## **CONNORSTONE ENGINEERING, INC.**

**Subject: Peer Review #1**  
**157-165 Lowland Street**

Connorstone Engineering, Inc. is in receipt of peer review comments provided by CMG in a letter dated July 8, 2022. Updated plans had been submitted on October 21, 2022 based upon the review, and a summary of each of the review comments is provided below.

CMG Peer Review, dated July 8, 2022:

**TURING MOVEMENT EXHIBIT (ENTERING)**  
**157-165 LOWLAND STREET**  
**HOLLISTON, MA**  
**SCALE: 1"=60'**

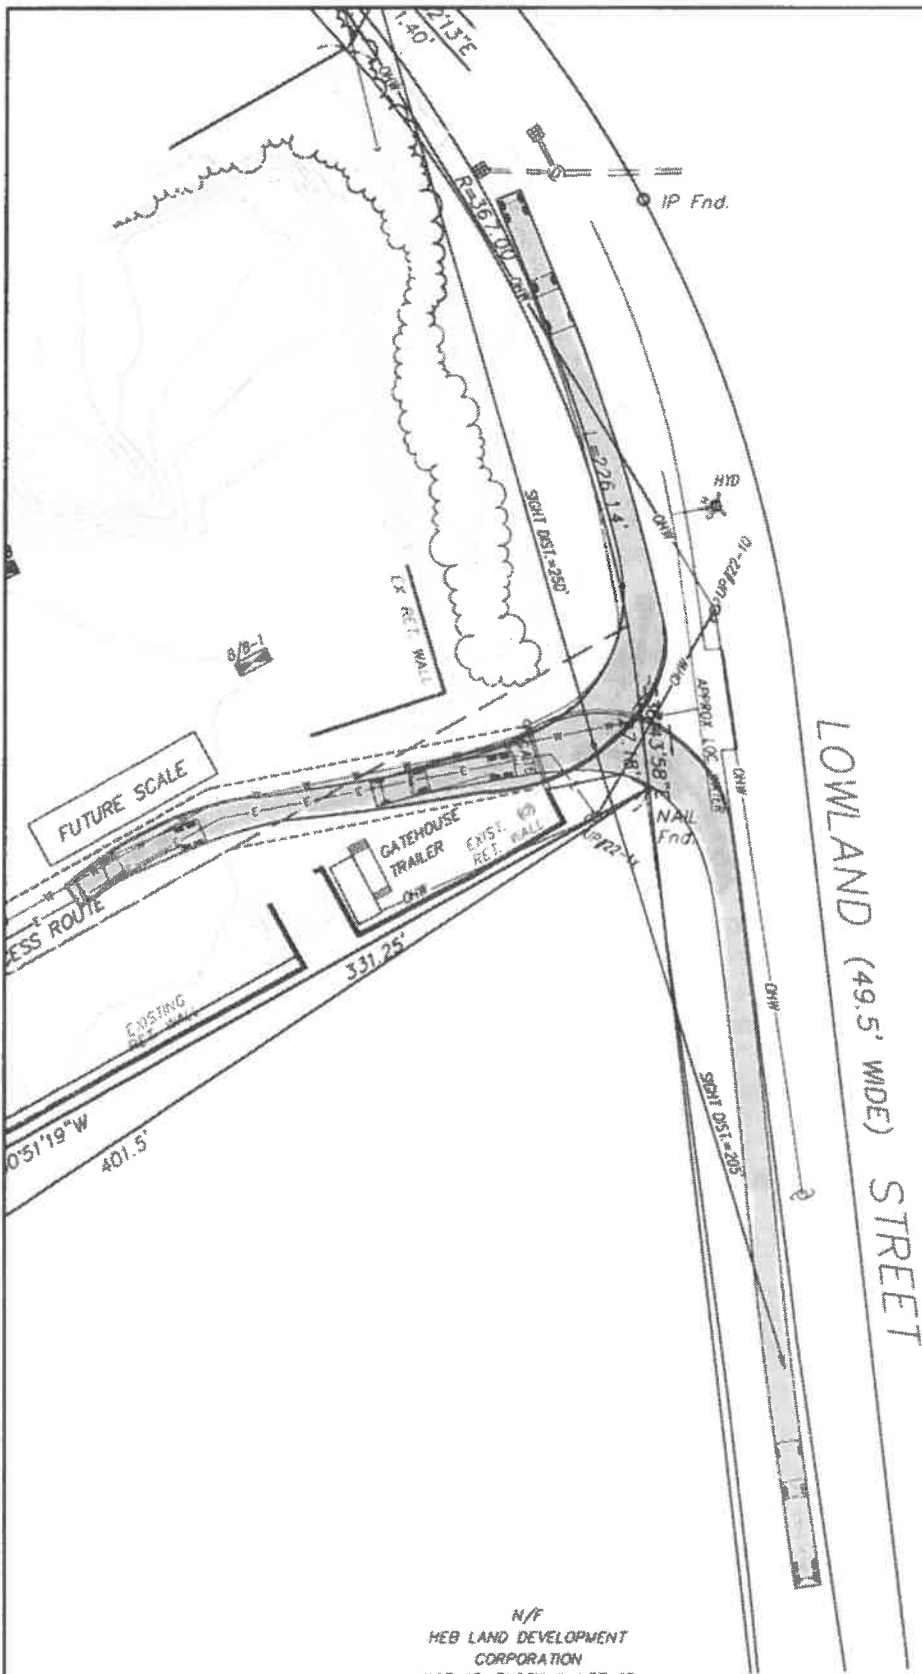
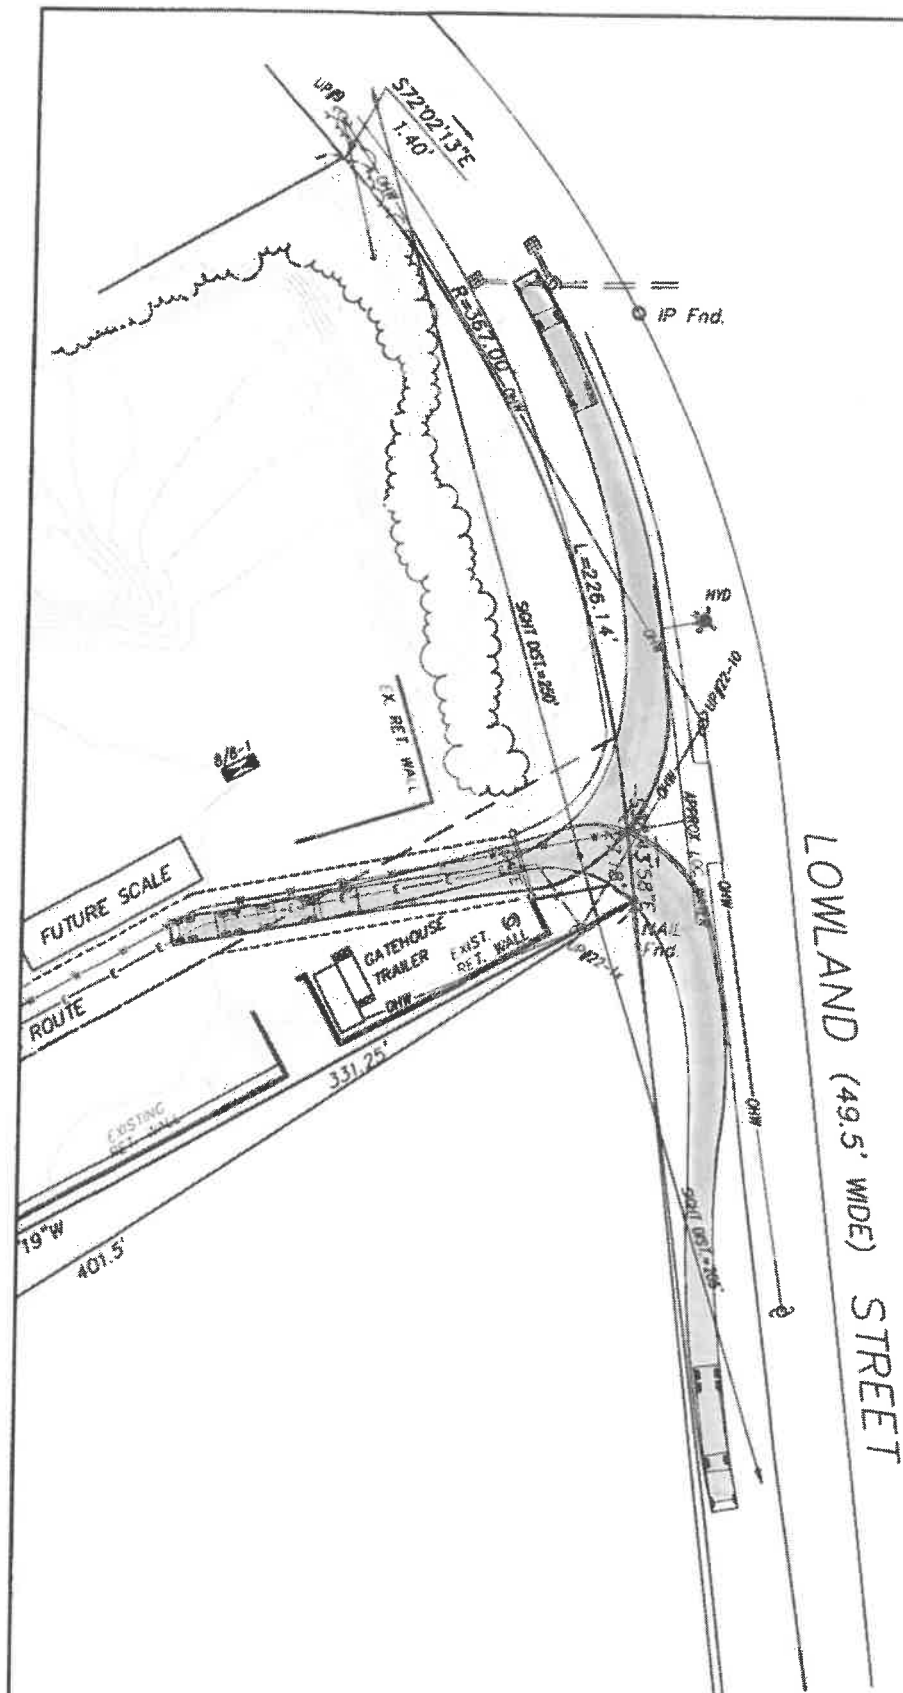
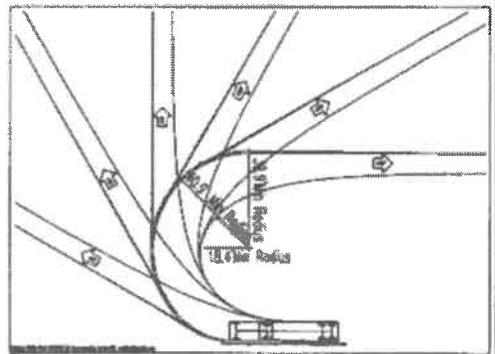
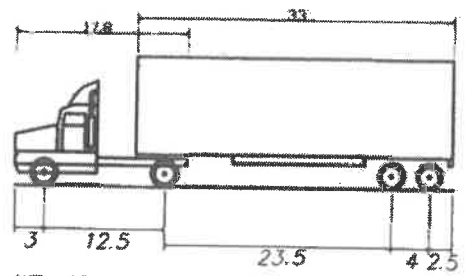
24. The sight distances have been added to the site plans.
25. A curb cut turning analysis has been attached to this letter to verify turning movements.

WB-40 - Intermediate Semi-Trailer

Overall Length	45.499ft
Overall Width	8.000ft
Overall Body Height	13.500ft
Min Body Ground Clearance	1.334ft
Track Width	8.000ft
Lock to Lock Time	4.00s
Curb to Curb Turning Radius	39.900ft

Turn(s) based upon a design speed of 5mph.
